09.25.23 Response to Request for Information in connection with The Invitation to Bid Construction Services: ITB No. 08-79-05624, Historical Museum of South Padre Renovation Project.

ADDENDUM NO. 1

PROJECT: Invitation to Bid Construction Services: ITB No. 08-79-05624 Historical Museum of South Padre Renovation Project

GENERAL NOTES & FOUNDATION DETAILS

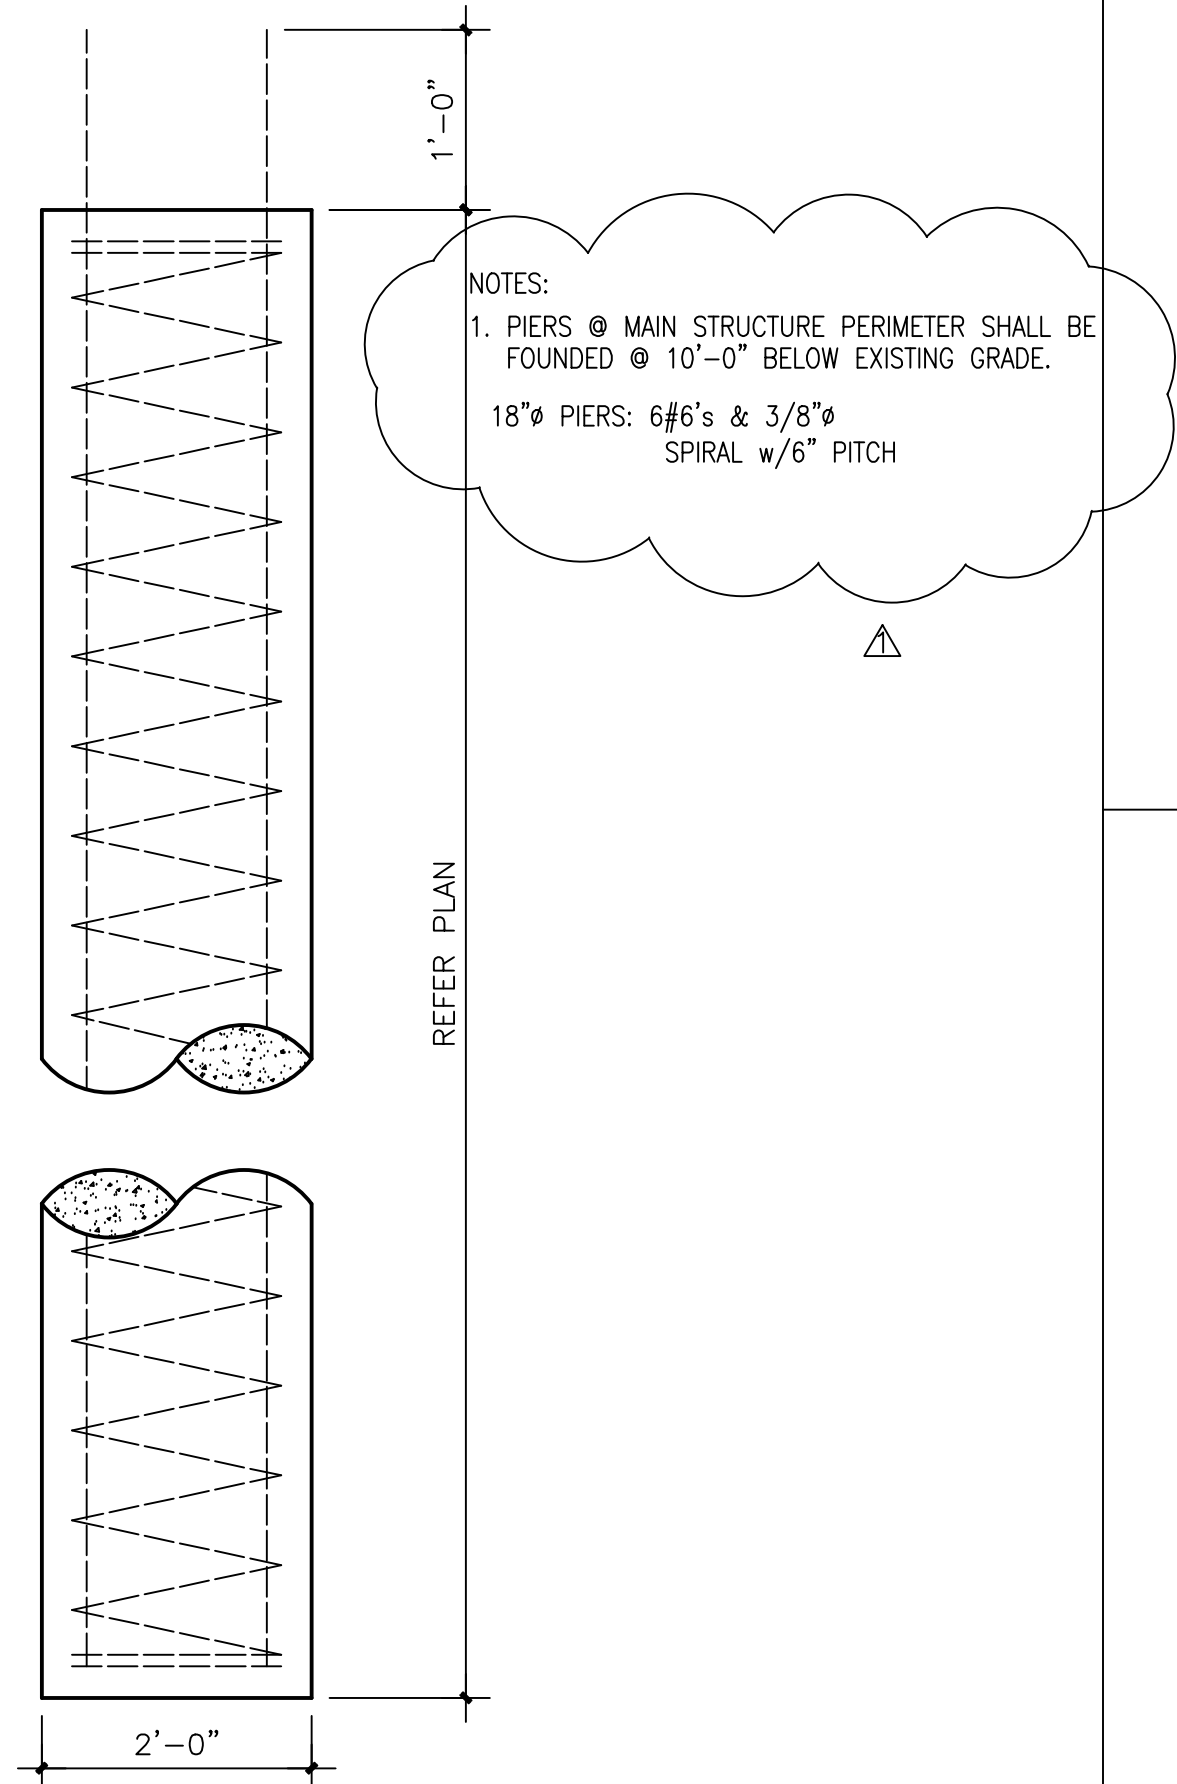
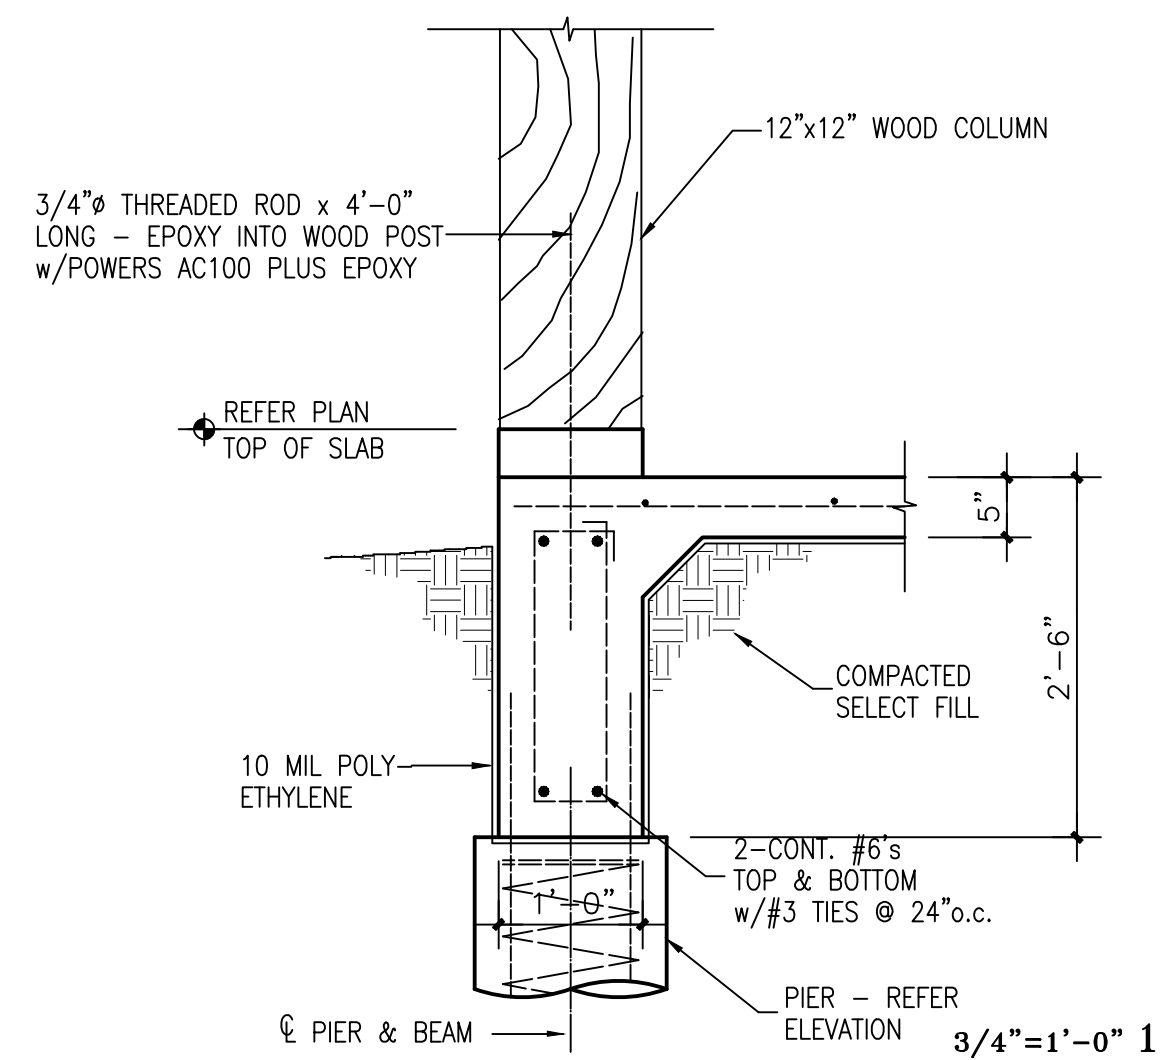
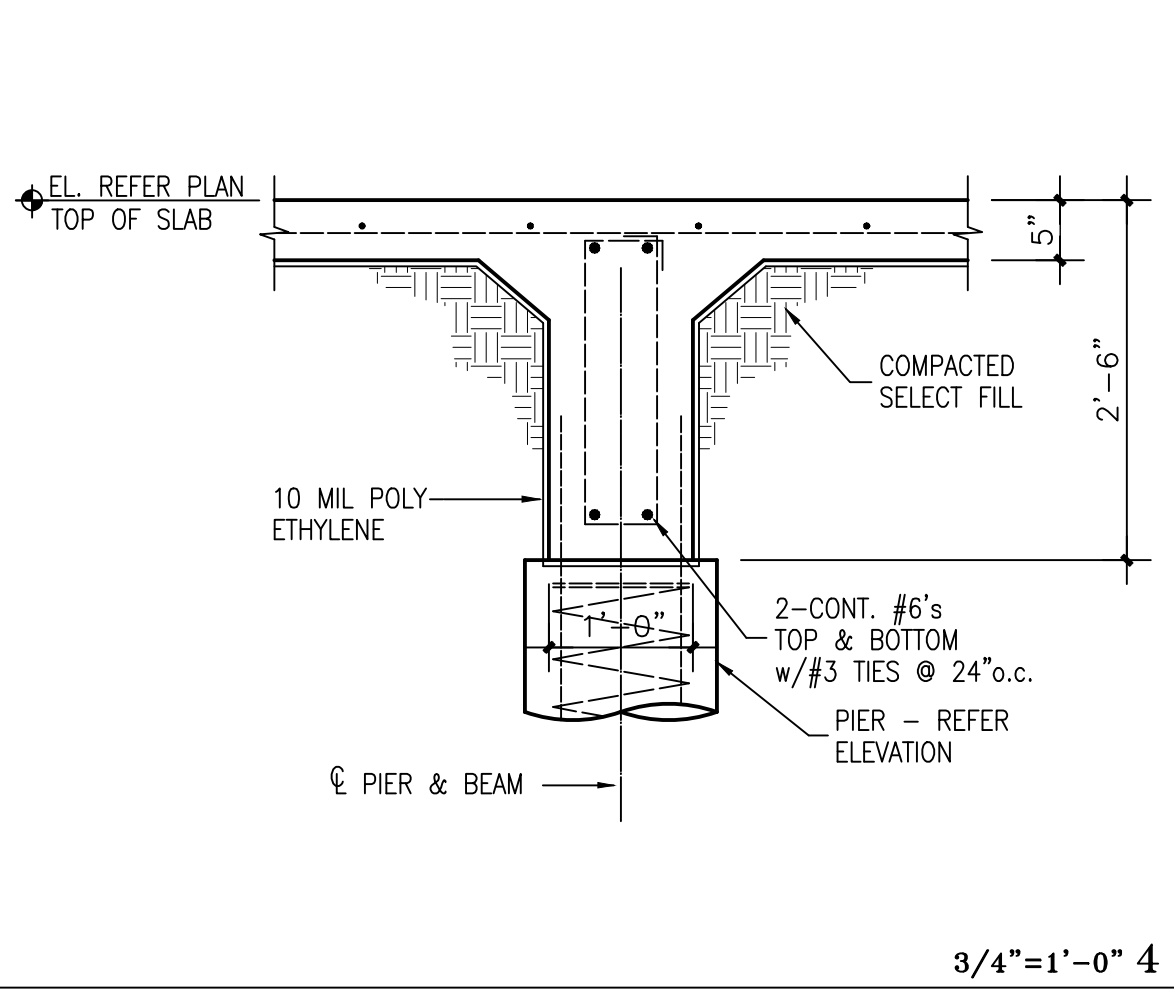
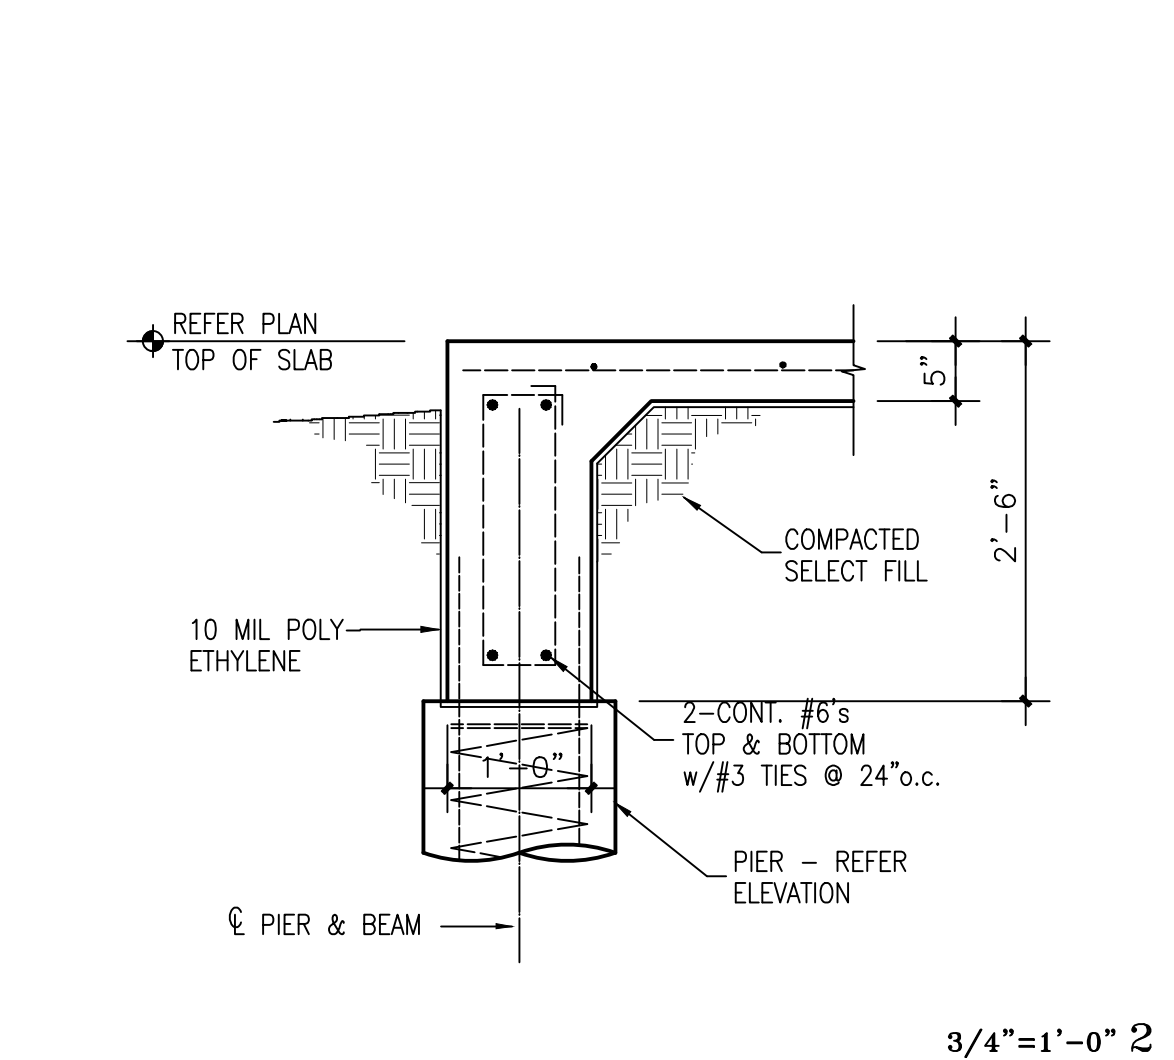
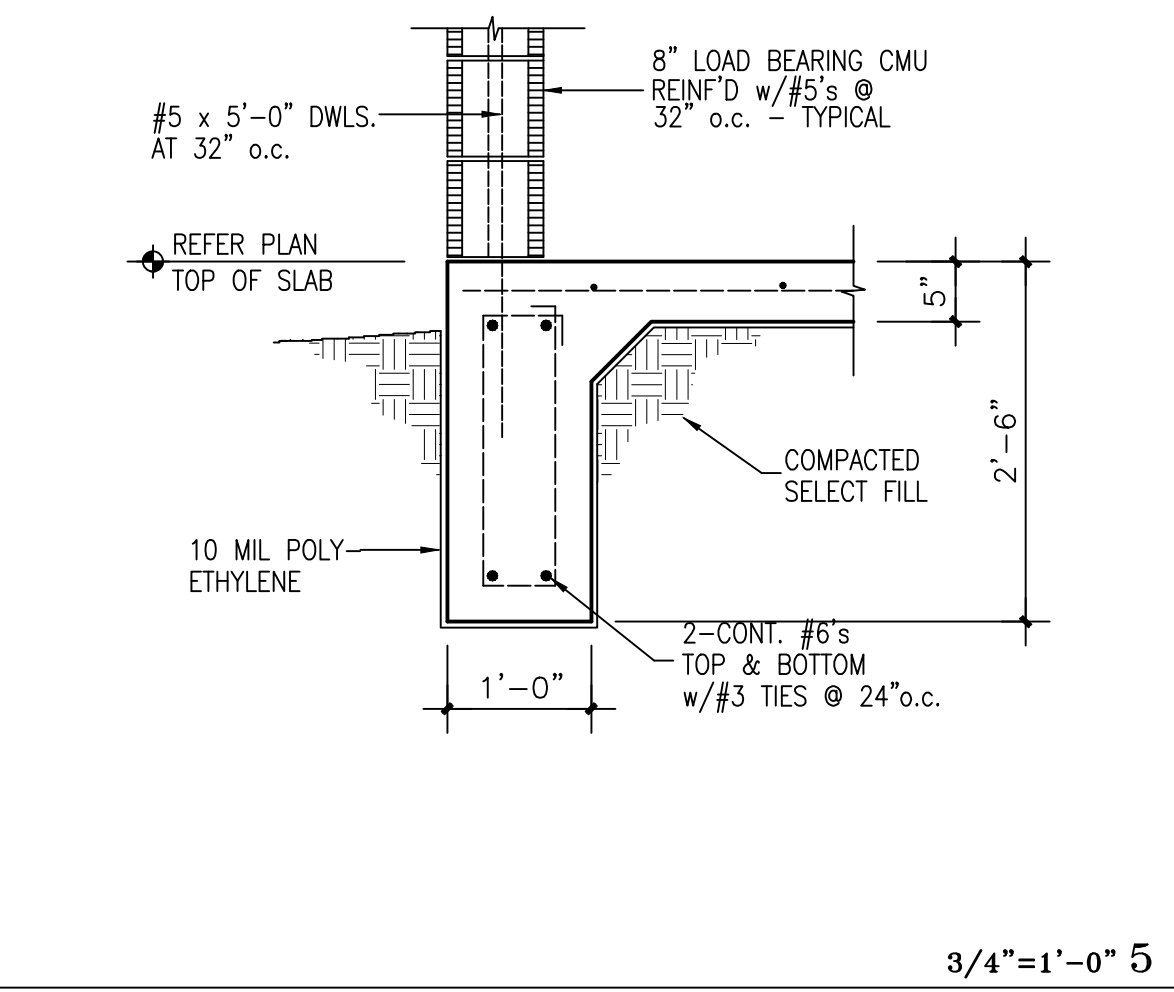
3. The Bathrooms-provide toilet compartment divider plastic laminate. Contractor shall shop drawings.
4. The Storage-there are no built-in details for the Storage Rooms.
5. Pilings are shown on the attached updated Structural Sheet S1, dated 09.24.23, attached hereto:
6. Contact Dennis Franke, at (956)761-0044, for any and all information regarding the Display Cabinets.
